# MERIT Primary Containment Status

**MERIT VRVS Meeting**

**January 25, 2006**

# Nozzle Position - Current

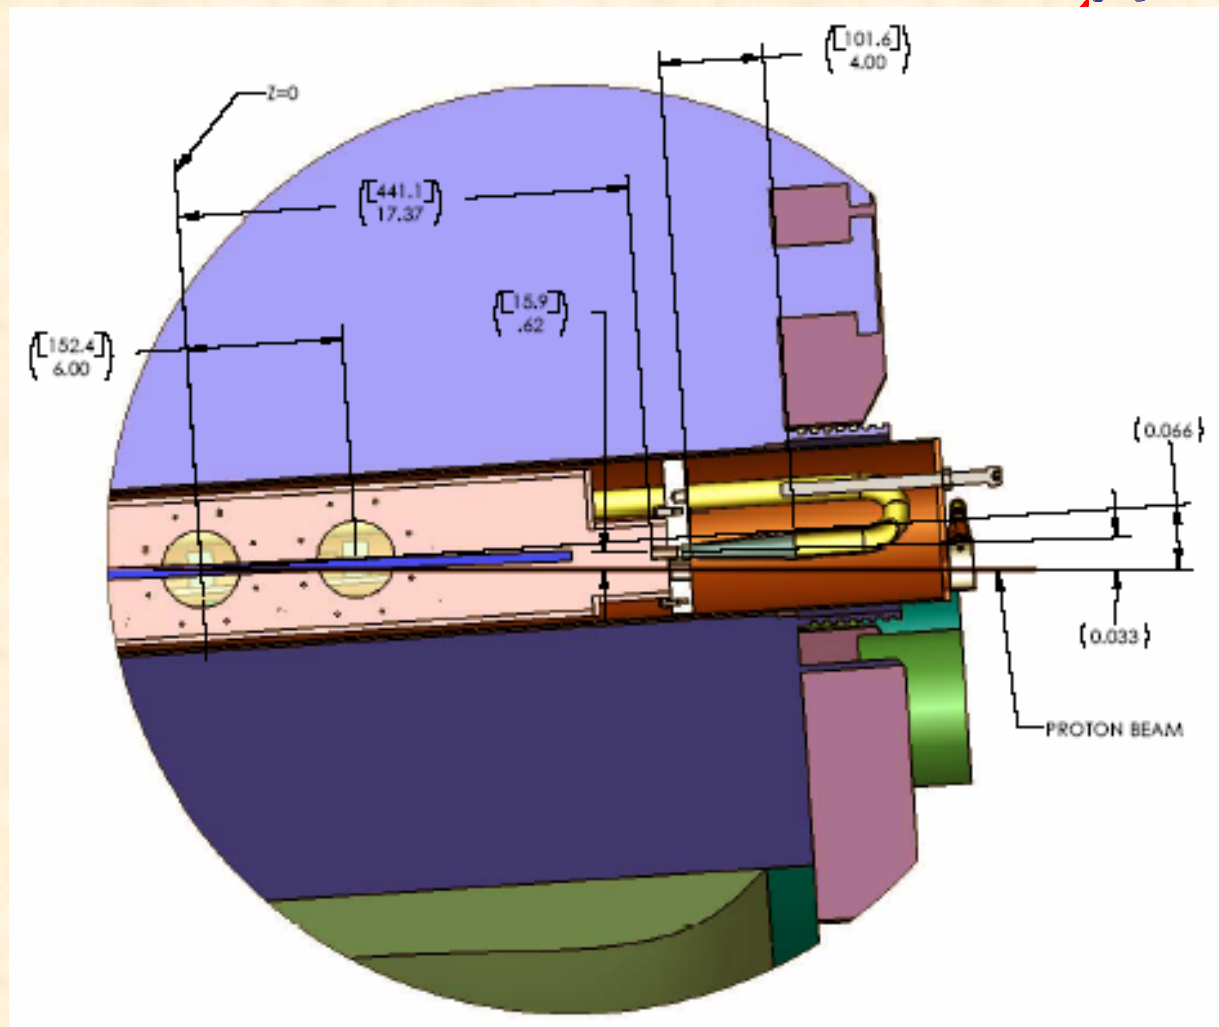
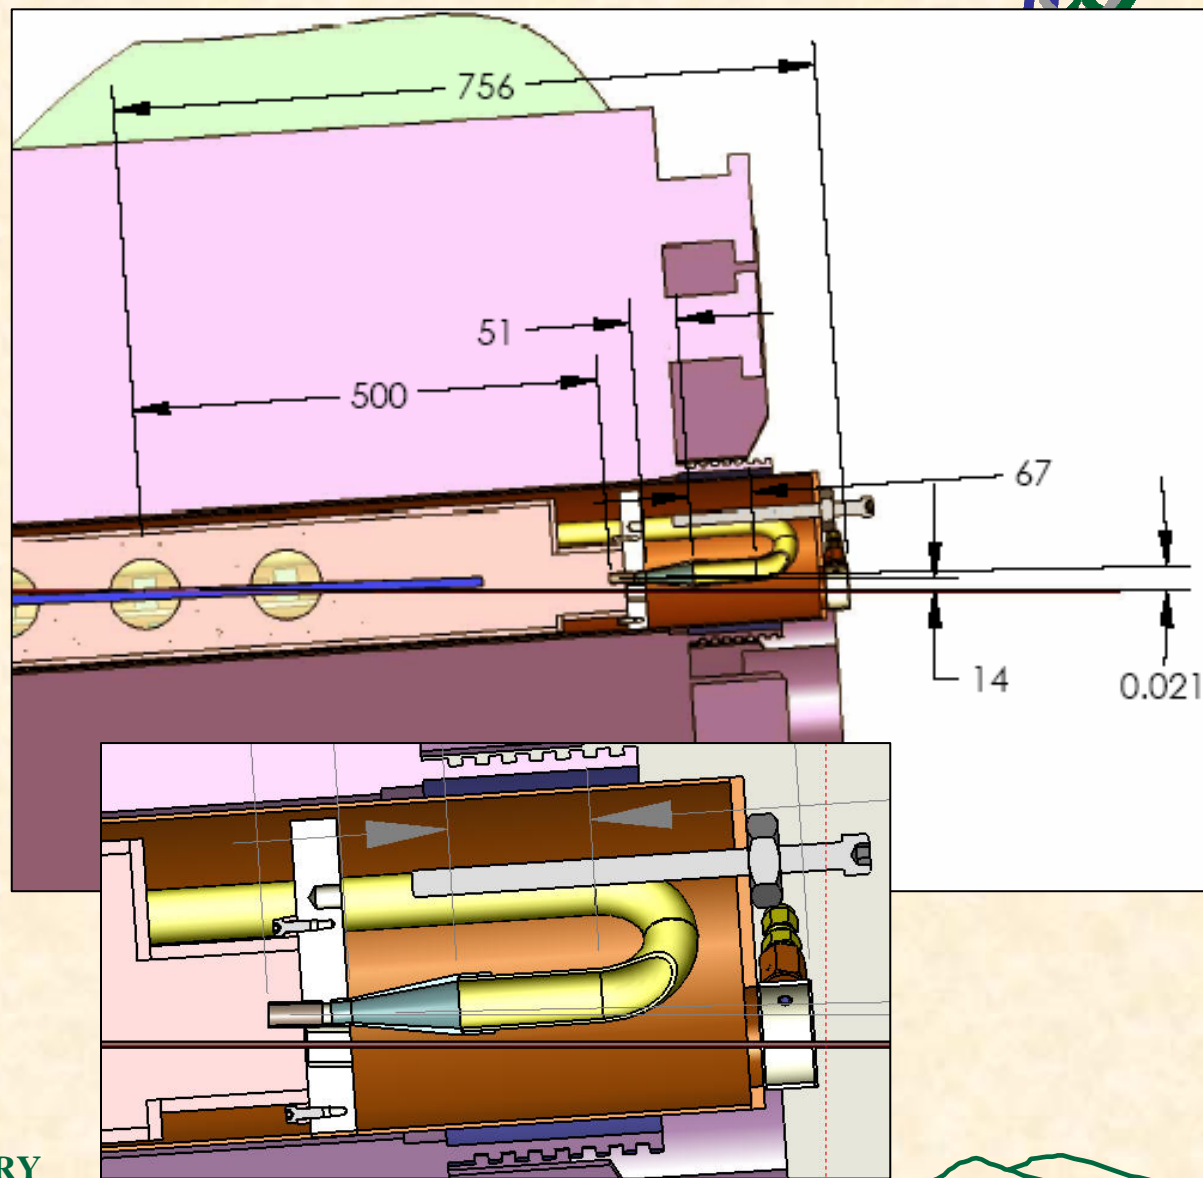
- **Start Z=-500mm**
  - Nozzle flange position changed
- **Angle 21mrad**
- **Elevation 14mm above beam**
- **Reducer length 51mm**
  - Reducer clearance minimal
- **Secondary window position unchanged**

- **Nozzle length unchanged, position shift obtained by lengthening primary containment**
  - Reduces room available for 180 bend and length of funnel
  - Secondary containment near its length limit
- **Subsequent nozzle changes occur at flange**
- **Clearance below funnel an issue, especially for beam scanning**
  - This is not a new discovery, upward scanning not feasible
- **Need to settle on nozzle parameters now!**

# Downstream End Can Change

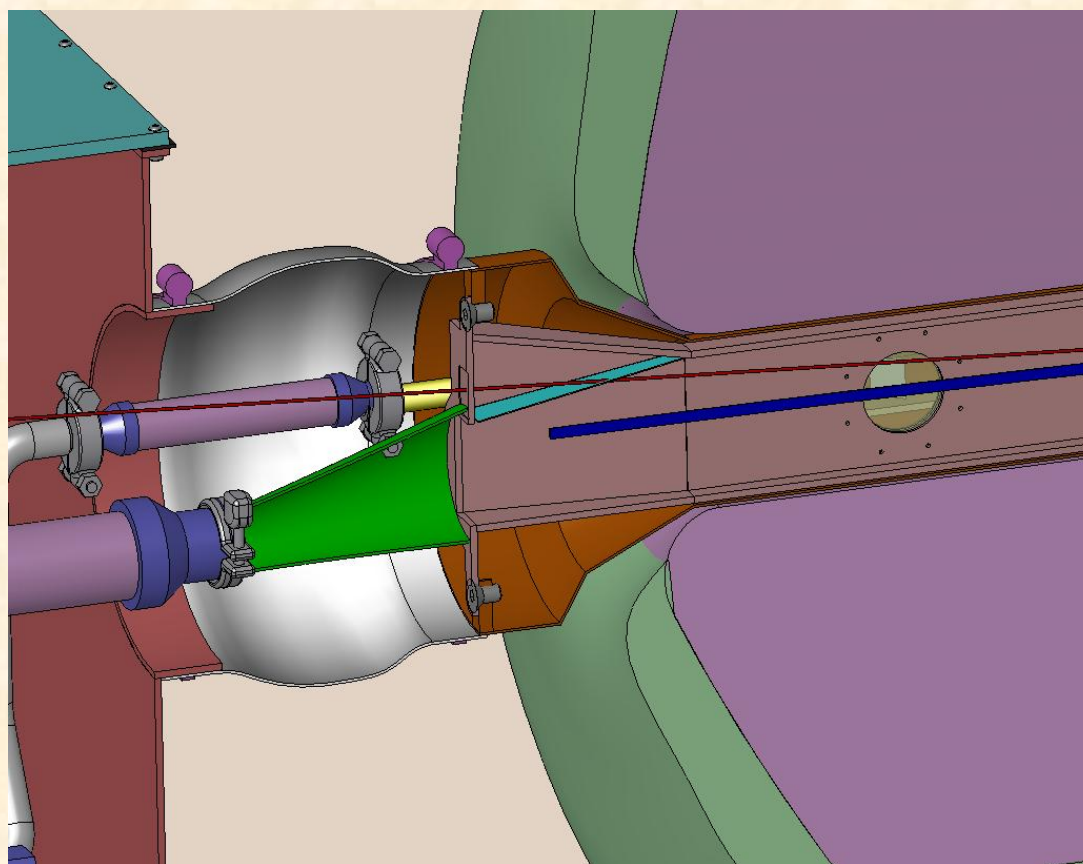
- **Consideration of all-Ti provided opportunity to refine downstream end of module**
- **Funnel was off-the-shelf item (SS) to transition from rect to round**
  - **Some interference with beam window noted**
- **Area above jet deflector not used**
- **Welding internal jet deflector not trivial**

# Value Engineering the Primary

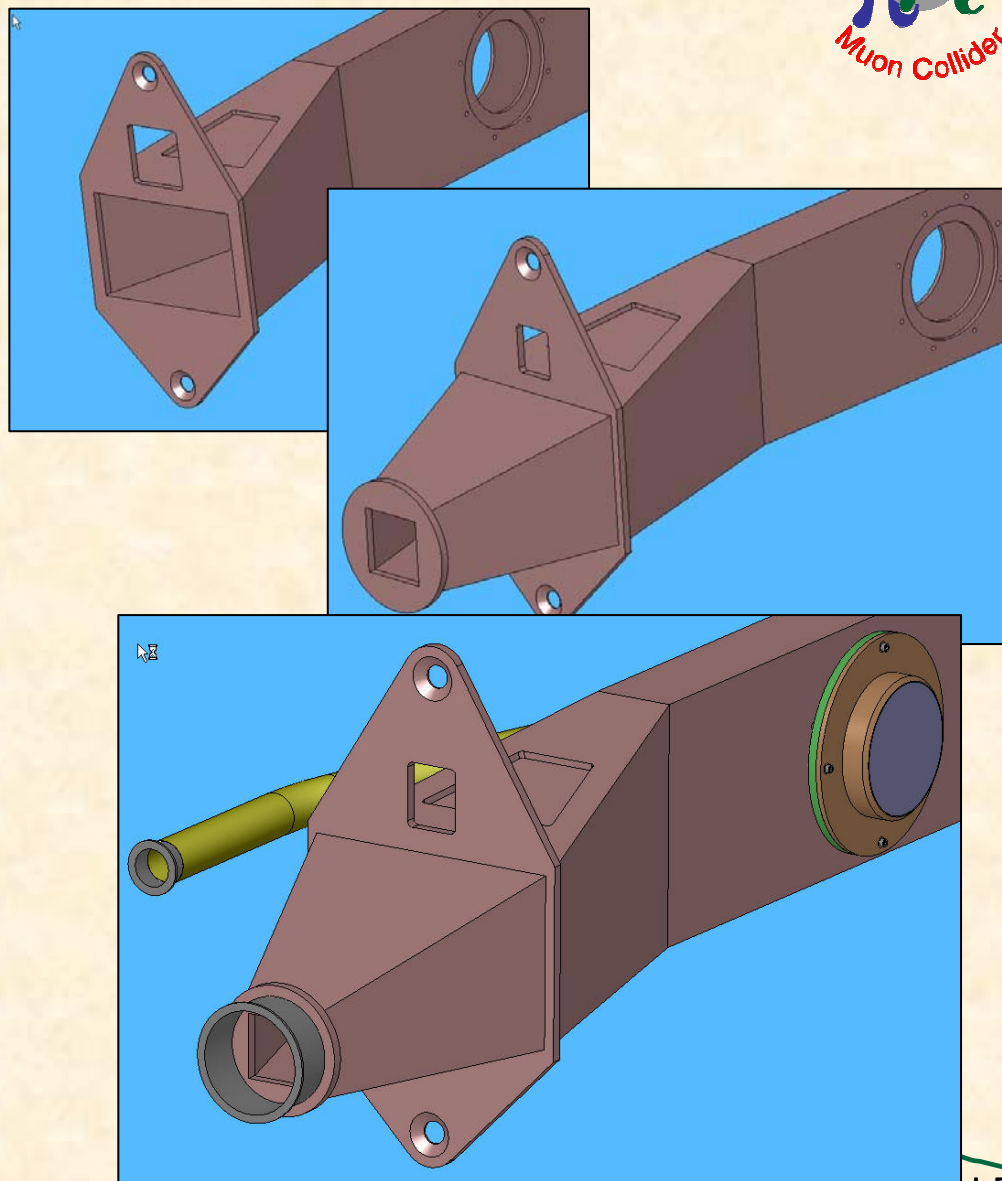
- Make the deflector the outer containment boundary
- 2mm-thick plate serves as beam window (beam path will be  $2/\sin\theta = 11\text{mm}$  for  $\theta=10^\circ$ )
- Replaces funnel with Ti weldment
- Custom-machined Ti sanitary flange also required

# Can Reduce Mfg Costs by Eliminating Flare

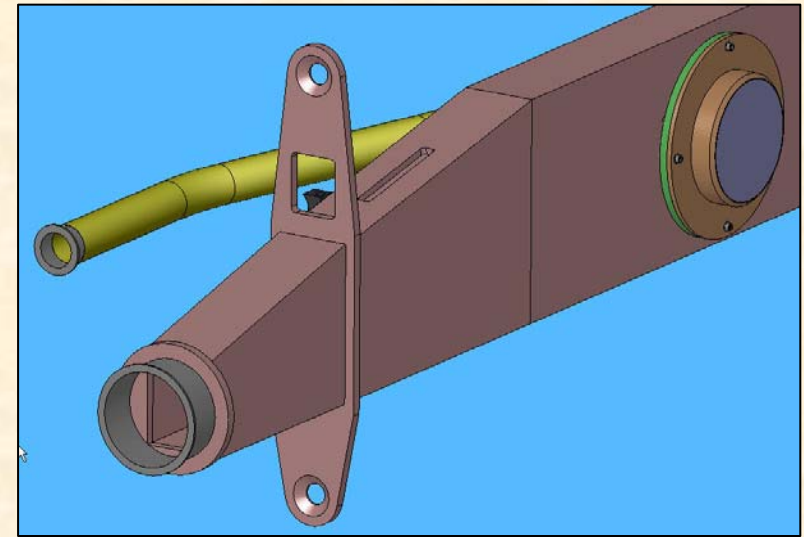
- **Titanium fabrication probably more expensive than SS**
- **Straight sides & bottom makes for relatively simple weldment**
- **Tabs can be added to interface with secondary containment**
- **Hg backsplash is major concern!**
  - Interior walls are smooth except for viewport edges
  - Spray collisions & sloped ceiling will delay Hg exit, but how much?
- **If water tests show major problems, back end could be removed and flare added before adding Hg, at the risk of schedule slippage**
  - Magnetic field may alleviate spray issues
